ADDENDUM

PROJECT: RFB# 930500-01 - 9305 DAS CC
Capitol North and South Stairs Repair

PROJECT NO.: 21818001

BID DATE: March 21, 2024 **ADDENDUM #** 01

A13 ENLARGED PLAN - SOUTH STAIR - NEW WORK
1/16" = 1'-0"

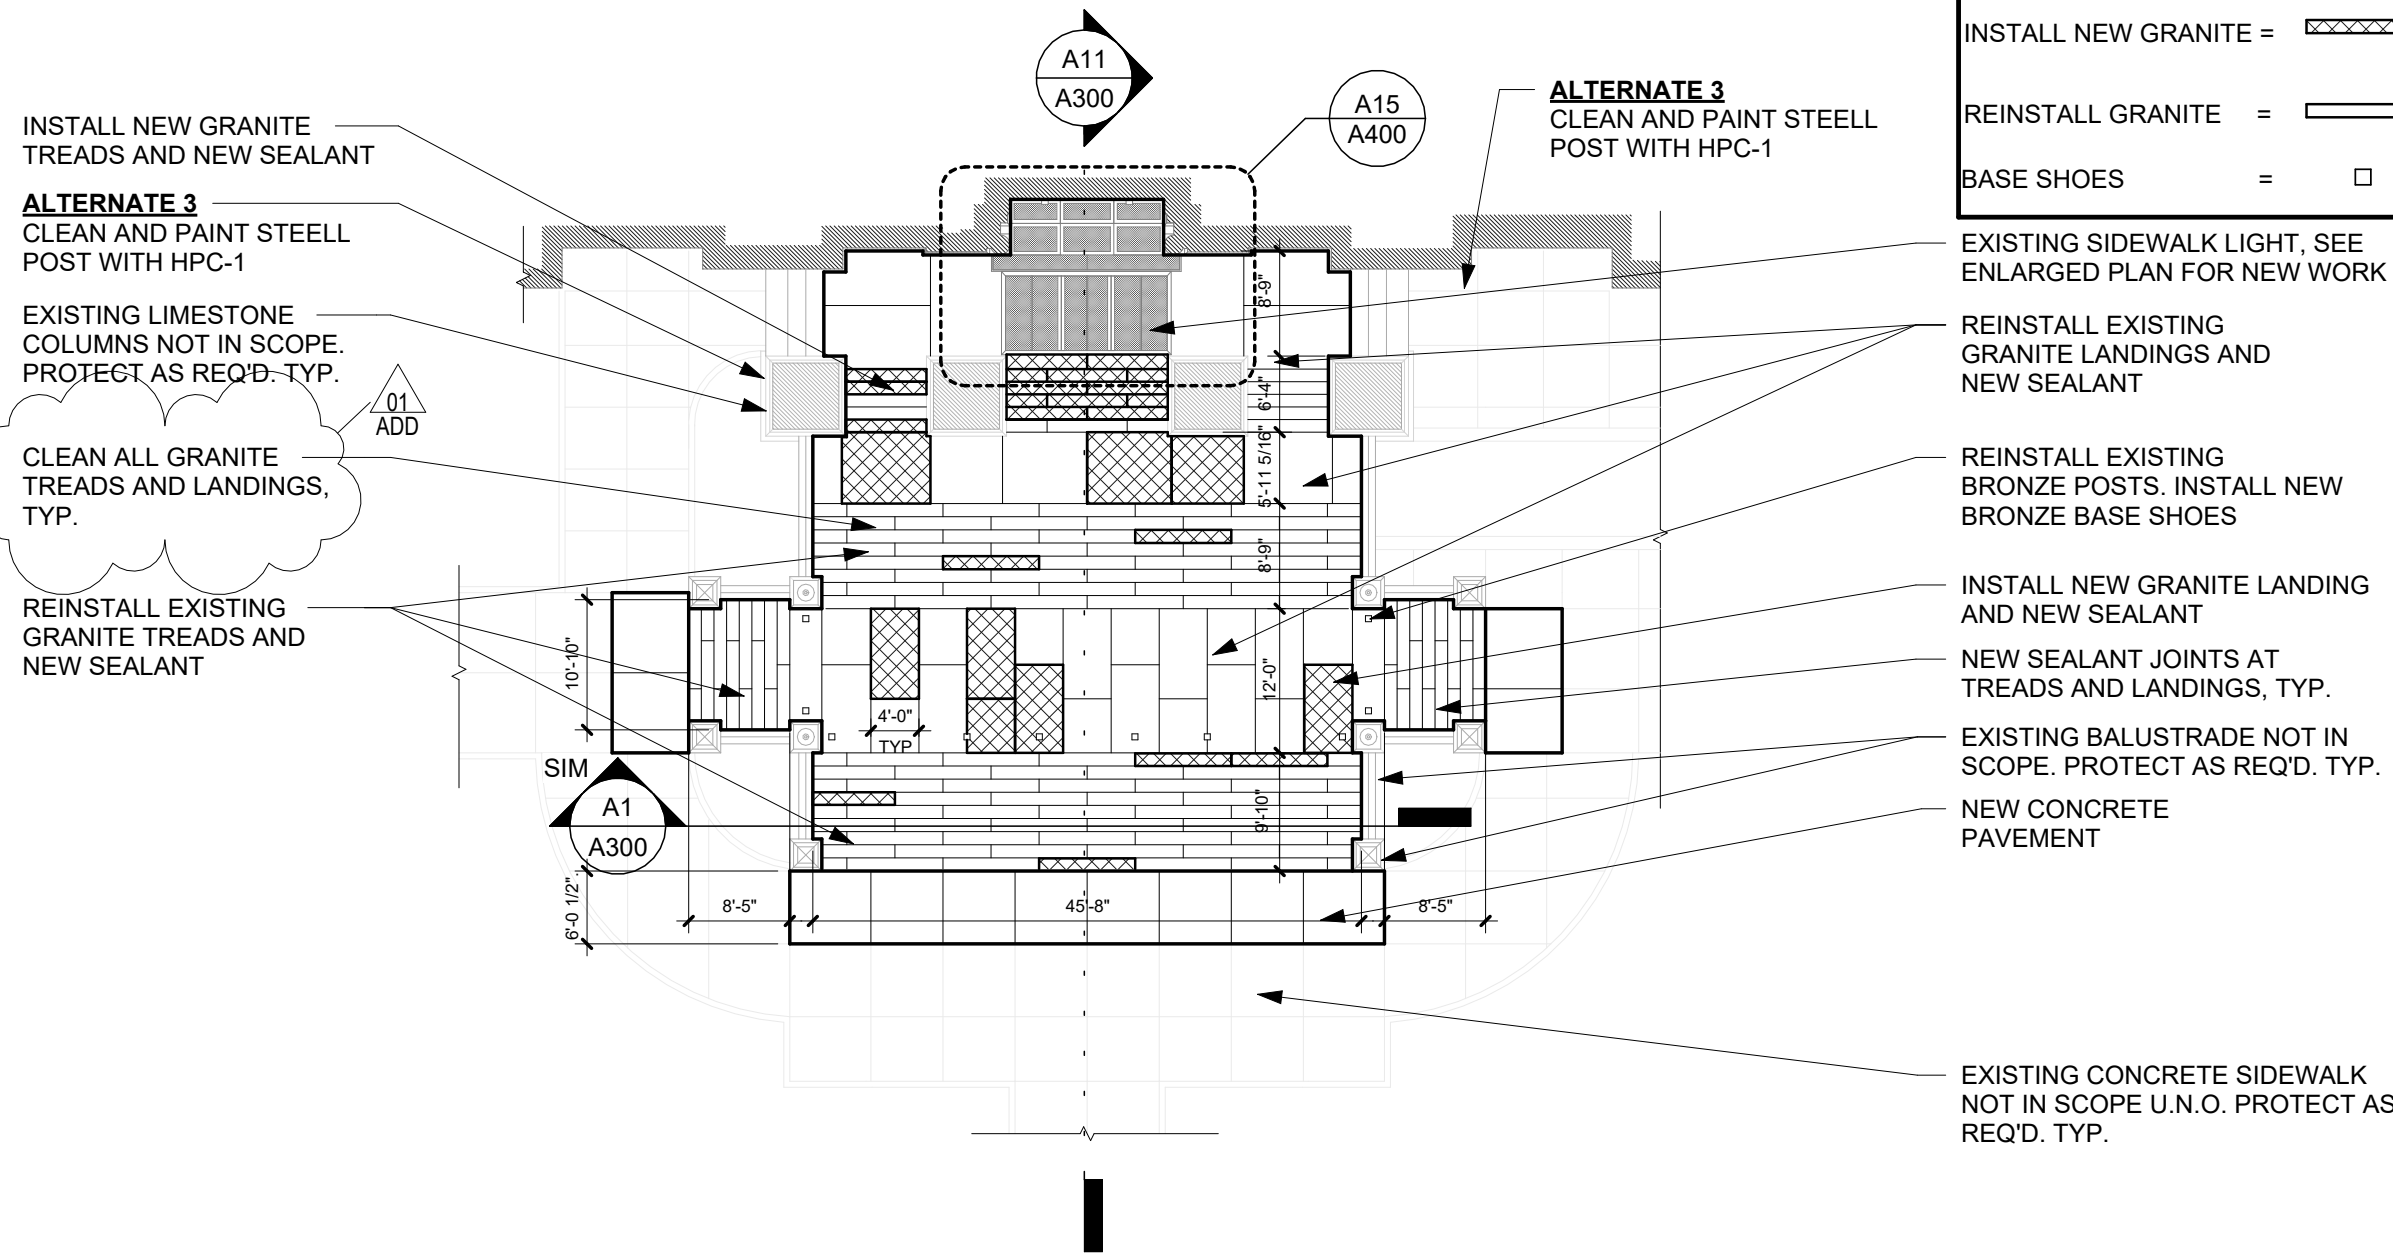
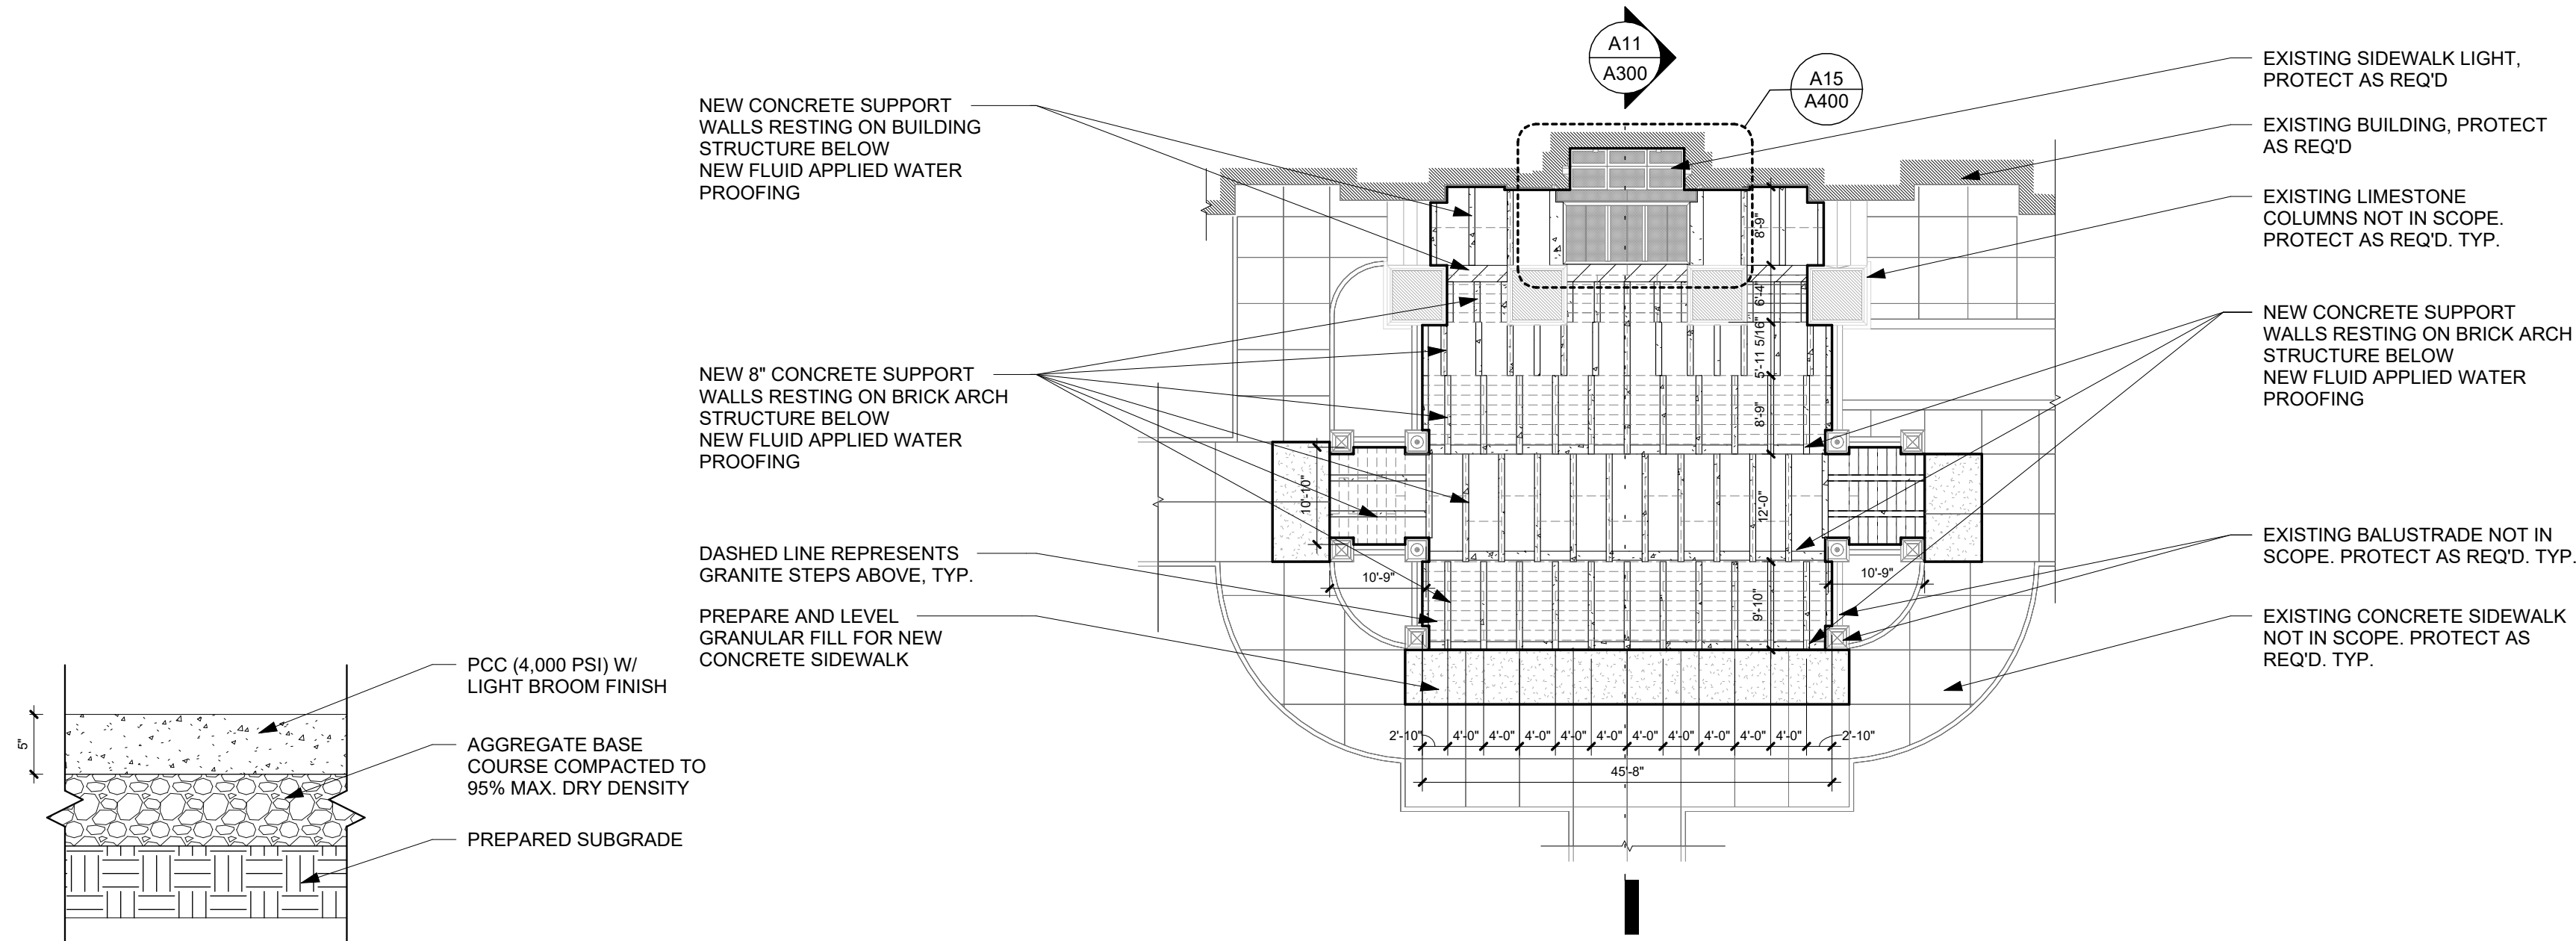
5.	K13/AD100	Add four treads for remove and dispose granite.
6.	A13/AD100	Add four treads for remove and dispose granite.
7.	A4/AD100	Revise the note from "skylight" to "sidewalk light"

8.	A13/AD100	Revise the note from "skylight" to "sidewalk light"
9.	K13/AD100	Revise the note from "skylight" to "sidewalk light"
10.	K4/AD100	Revise the note from "skylight" to "sidewalk light"

11.	K13/A100	Revise note to delete the words "and polish"
12.	A13/A100	Revise note to delete the words "and polish"
13.	F15/A400	Revise the drawing title from "skylight" to "sidewalk light"

F15 DETAIL SECTION - WATERPROOFING CONNECTION AT SIDEWALK LIGHT
3" = 1'-0"

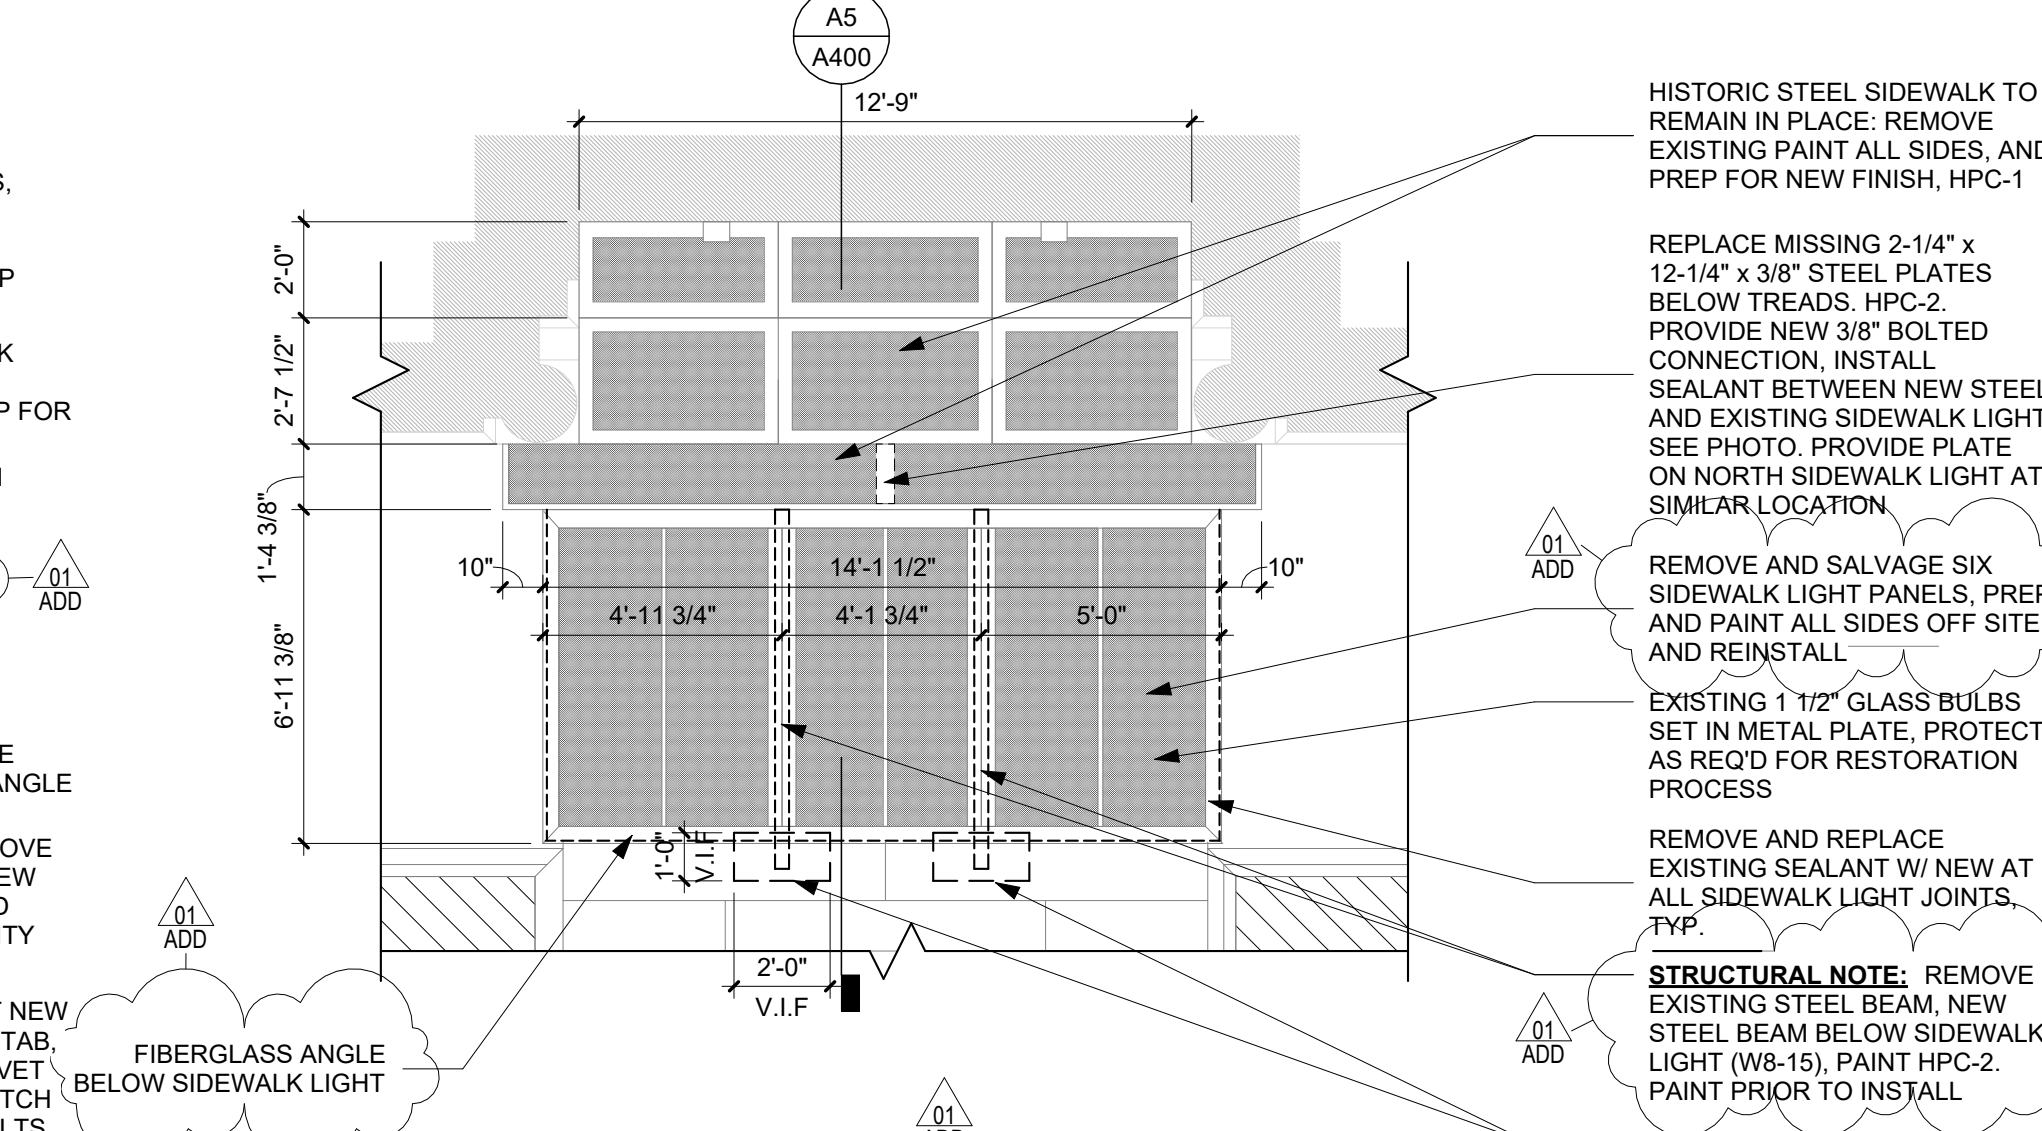
14.	A15/A400	Revise the drawing title from "skylight" to "sidewalk light"
15.	F15/A400	Revise the note in three locations from "skylight" to "sidewalk light"
